ATtiny87/167 Automotive

Automotive Silicon Errata and Data Sheet Clarifications

Figure 2-1. The Break Field

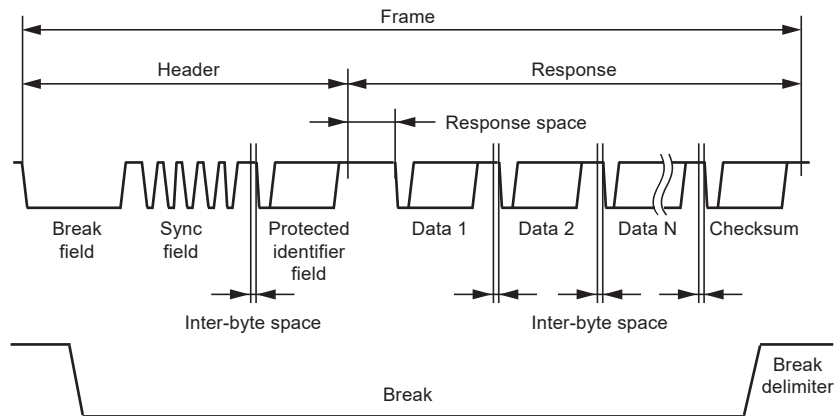
In SLAVE MODE, a BREAK field detection error can occur under the following conditions.

The problem occurs if two conditions occur simultaneously:

1. The DOMINANT part of the BREAK is $(N+0.5)*T_{bit}$ long with $N=13, 14, 15, \dots$
2. The RECESSIVE part of the BREAK (BREAK DELIMITER) is equal to $1*T_{bit}$. (See the note below).

The BREAK_high is not detected, and the 2nd bit of the SYNC field is interpreted as the BREAK DELIMITER. The error is detected as a framing error on the first bits of the PID or subsequent Data or a Checksum error.

There is no error if BREAK_high is greater than $1 \times T_{bit} + 18\%$.

Note: LIN2.1 protocol specification paragraph 2.3.1.1 Break field says (www.microchip.com/mymicrochip/filehandler.aspx?ddocname=en590544): "A break field is always generated by the master task (in the master node) and it shall be at least 13 nominal bit times of dominant value, followed by a break delimiter, as shown in Figure 2-1. The break delimiter shall be at least one nominal bit time long."

None

3.4 Package Marking Information

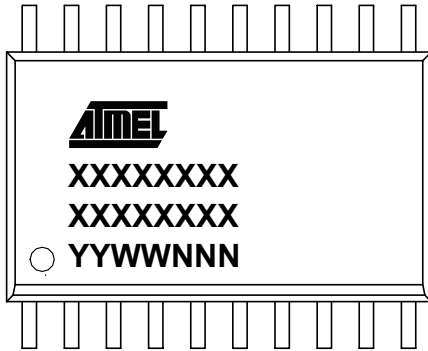
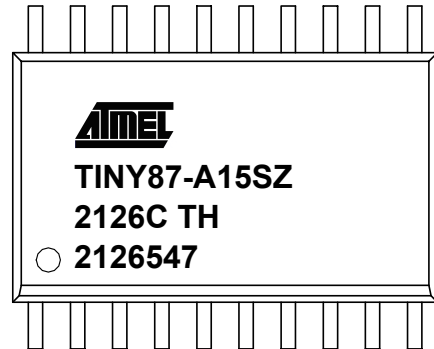
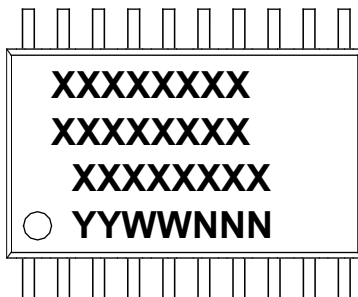
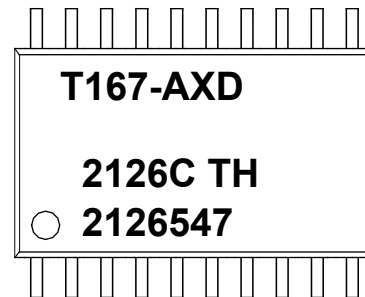
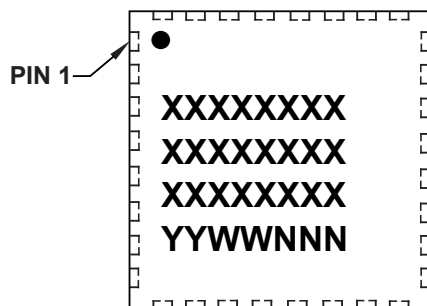
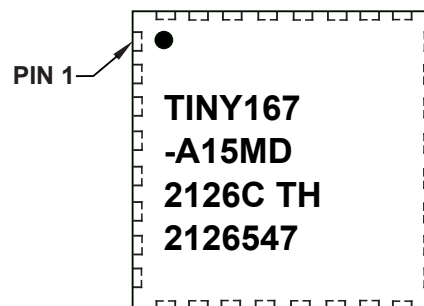
Legend:	XX...X	Customer-specific information or Microchip part number
	Y	Year code (last digit of calendar year)
	YY	Year code (last 2 digits of calendar year)
	WW	Week code (week of January 1 is week '01')
	NNN	Alphanumeric traceability code
	(e3)	Pb-free JEDEC [®] designator for Matte Tin (Sn)
Note:	In the event the full Microchip part number cannot be marked on one line, it will be carried over to the next line, thus limiting the number of available characters for customer-specific information.
